Access Compliance Report

Public Rights-of-Way

| Intersection ID: 48391 | Main Street: RICHARD_ROZZELLE_DR | Cross Street: JOE_MORRISON_LN | Location: SW |
| ADA ID: 0764F2B33088 | Ramp Type: PerpDiag | Initial Pass/Fail: Fail | Overall Compliance: No |

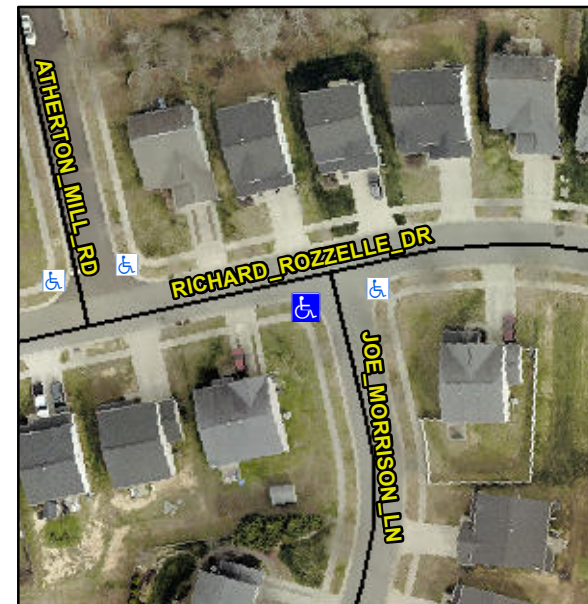
| Severity Score: 21.25 | | | |

R304.5.1, R304.5.3

| Compliance | Description | Data | Compliance | Description | Data |
|------------|-----------------------|------|------------|-----------------------------|------|
| No | Ramp Width (in) | 47.0 | No | Ramp XSlope (%) | 5.3 |

Remove & Replace Curb Ramp With Two New Directional Ramps or Equivalent.
